DEVELOPMENT REVIEW BOARD
SUPPLEMENTAL SUBMITTAL

Project Location: Whataburger – Volcano Rd. & 98th St.
DRB Project Number: PR-2019-002402

Bowman Consulting is in receipt of the comments dated January 12, 2022, issued by City of Albuquerque for the Whataburger restaurant at NEC of Volcano Rd. & 98th St, Albuquerque, NM 87121. Please see below for the responses to the comments:

SITE PLAN

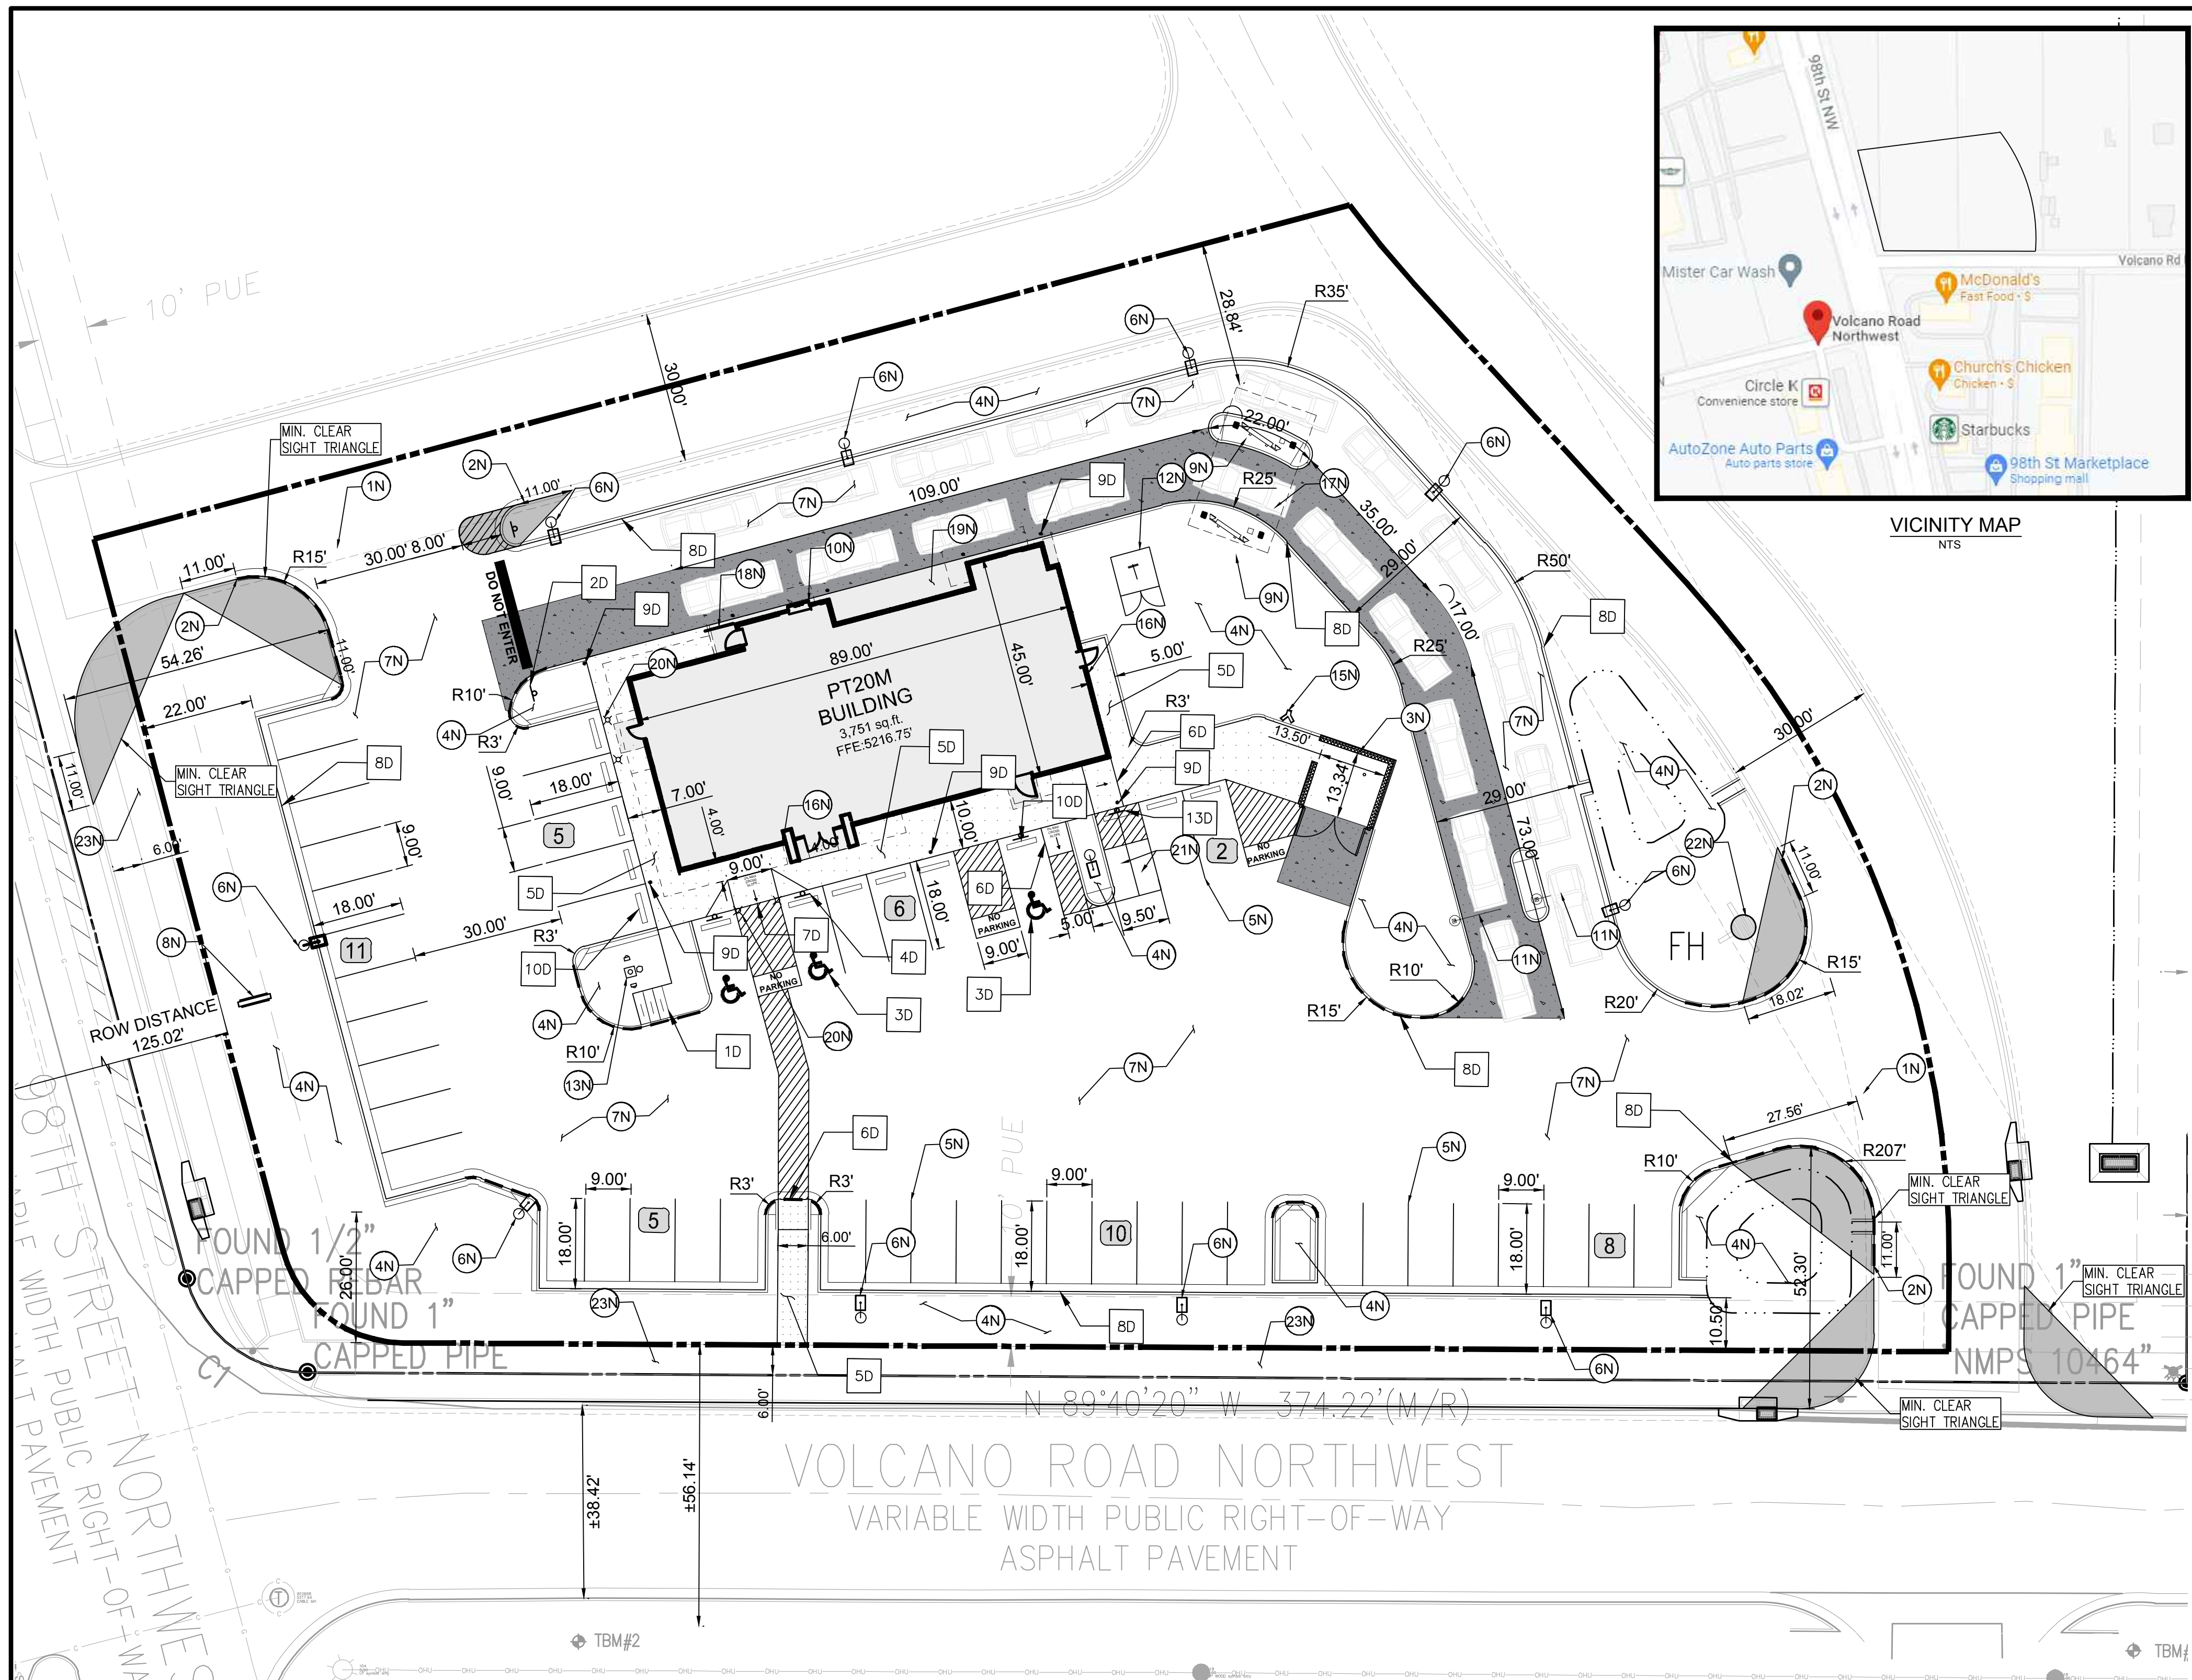
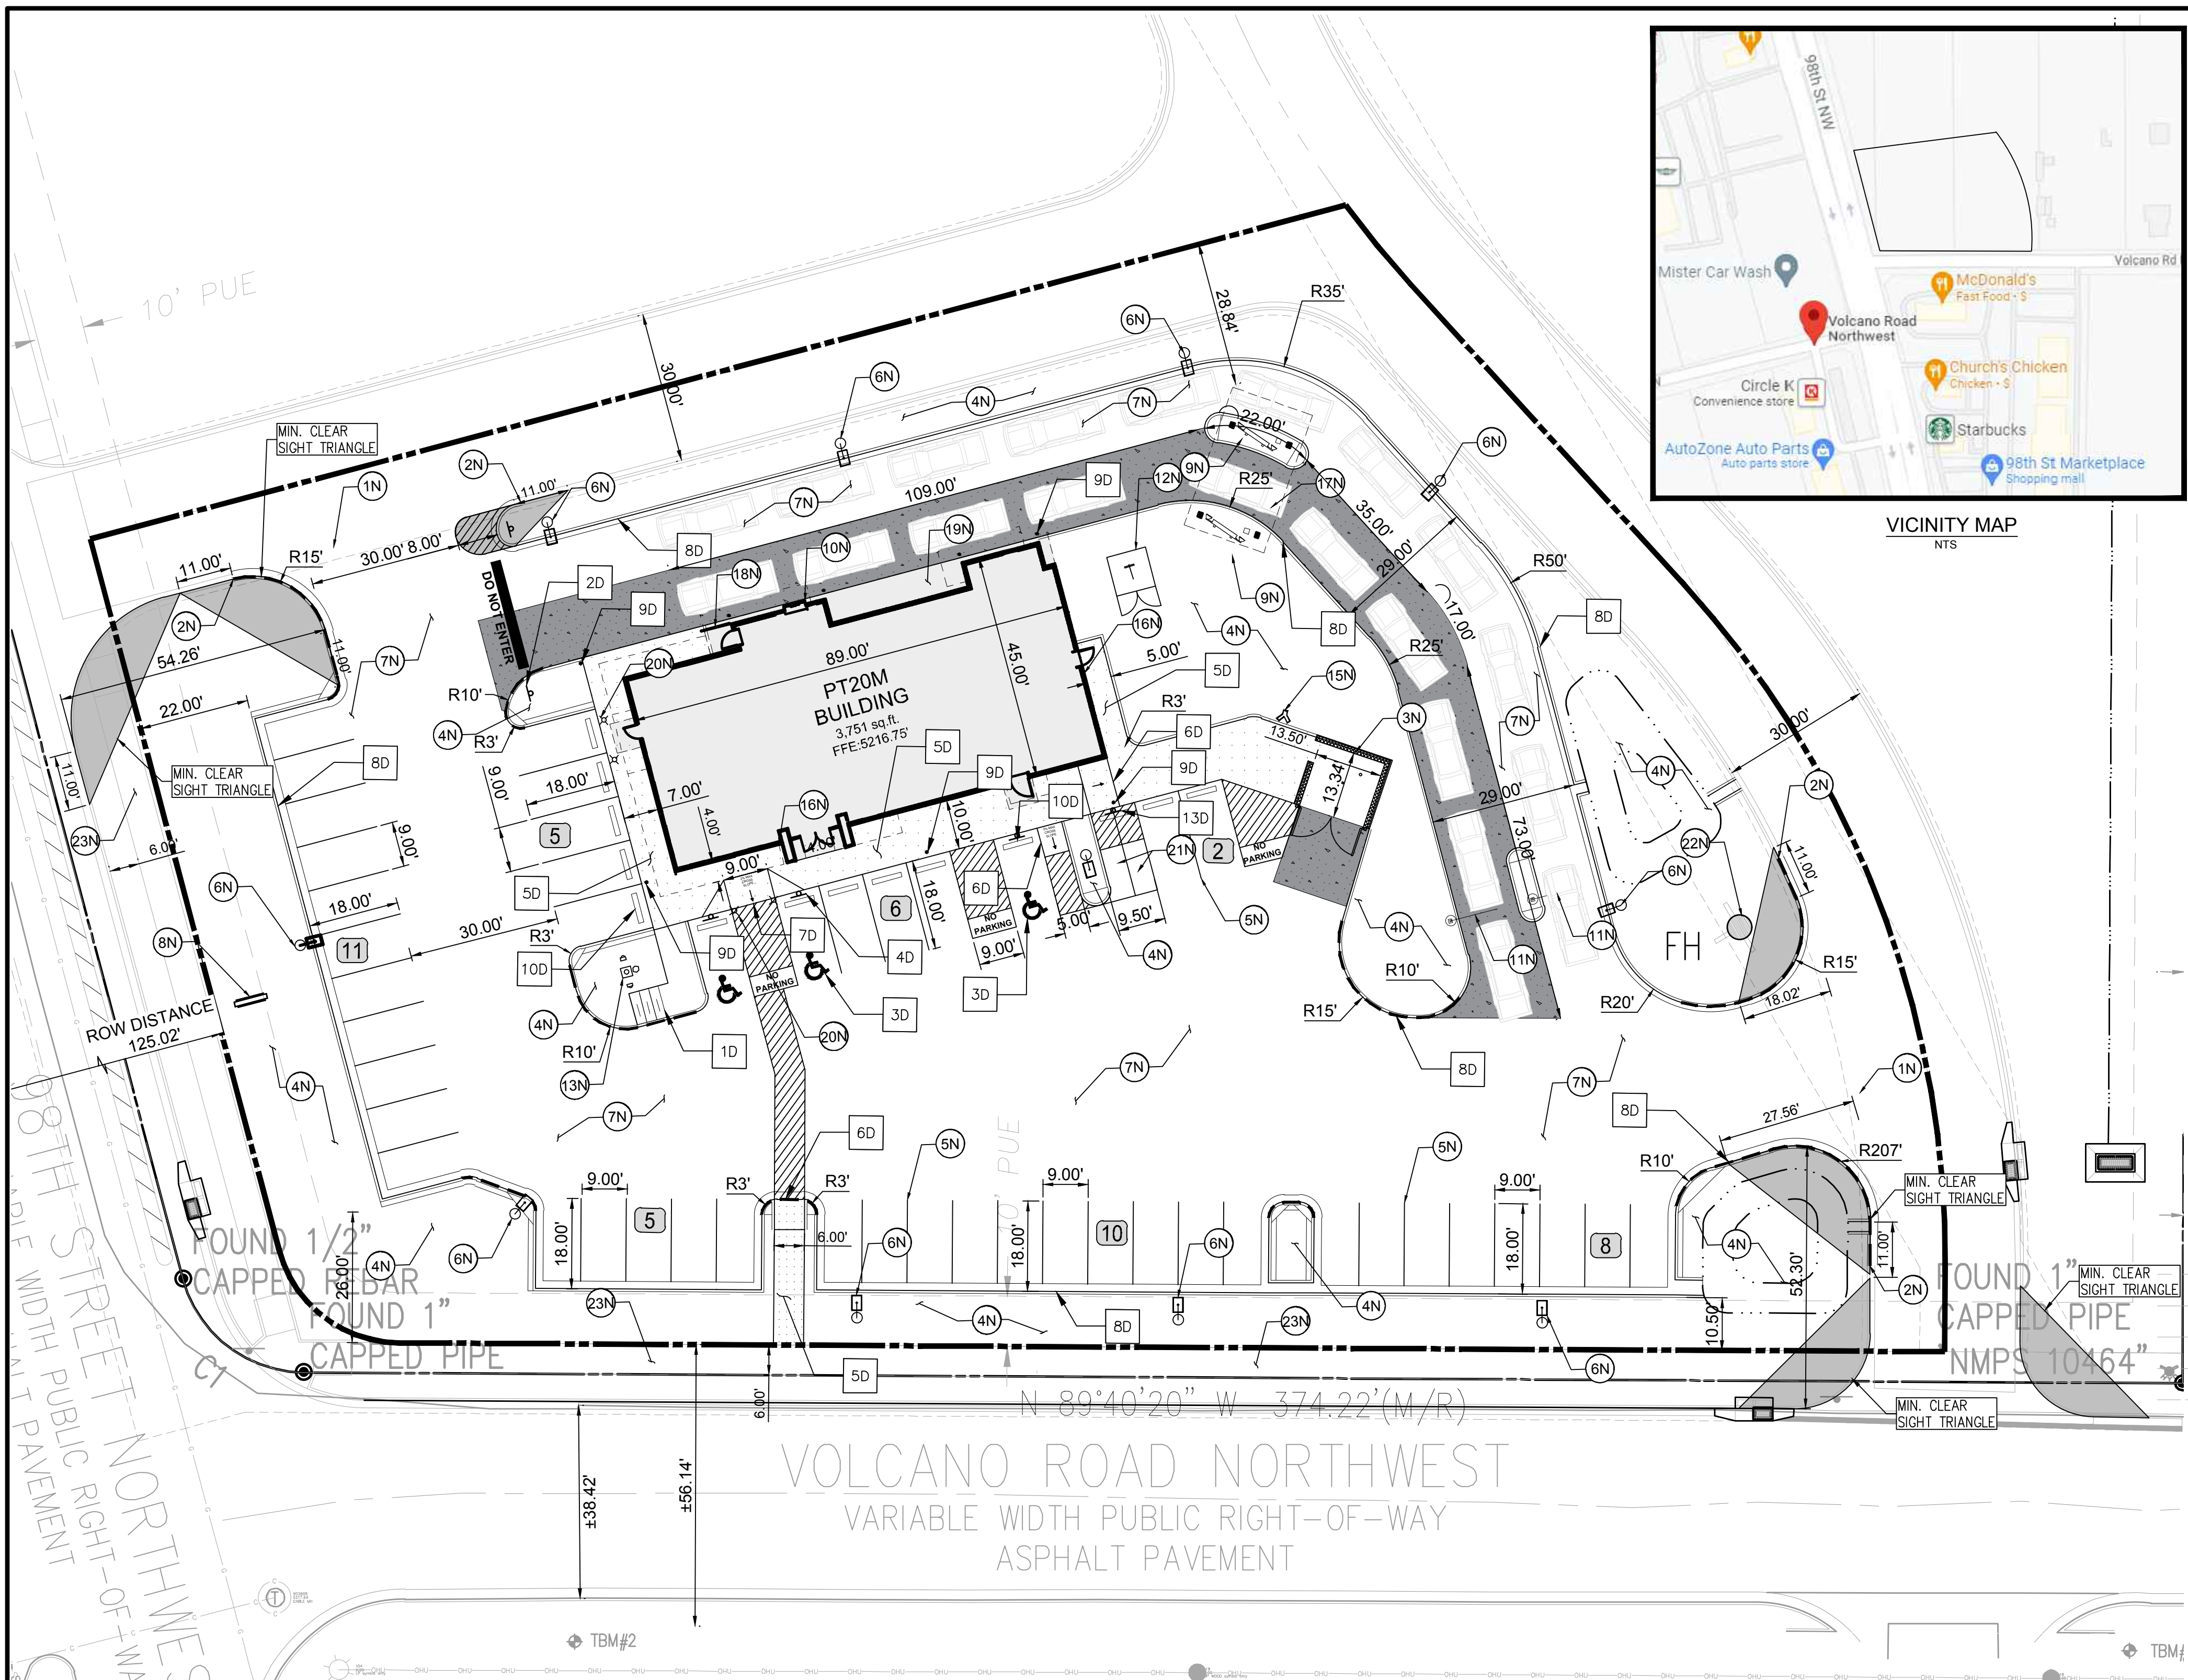
- Comment 5:** For the one-way aisle within the drive-thru, provide an additional “Do Not Enter” sign at the egress and directional arrows on the pavement. Also, add a One-way sign.

- Comment 7:** For the handicapped ramp at the accessible aisle, ensure that there is a minimum 4-foot dimension between the wing of the ramp and the corner of the building.

- Comment 10:** On 98th Street, use a clear sight triangle for intersection sight distance to be sure that there are no conflicts with the proposed landscaping. For the other sight triangles, show these outside of the pavement area per the DPM graphics.

Comment 1: Sheet C3.0 Site Plan is not needed for review and approval. There is information on this sheet that needs to be on the Grading & Drainage Plan. See Below.

Response: One way signage and directional arrows on pavement have been added to the site plan.
- Comment 6:** A sufficient throat length shall be provided to the public right-of-way per DPM requirements based on proposed building square footage. (There is also concern about the proximity of the drive off the private roadway to 98th Street and the conflicting movements between vehicles exiting the site versus cars entering the subdivision from 98th Street.)

Response: A dimension label has been added showing the
- Comment 8:** Show motorcycle parking signage in the details.
Response: Accompanying the site plan resubmittal is a construction detail sheet showing motorcycle parking signage.

Response: Sight triangles have been revised to show no conflict with proposed landscaping.
- Comment 11:** Place the text, “No Parking” on the back of the accessible aisles.

Response: Comment noted. Thank you.
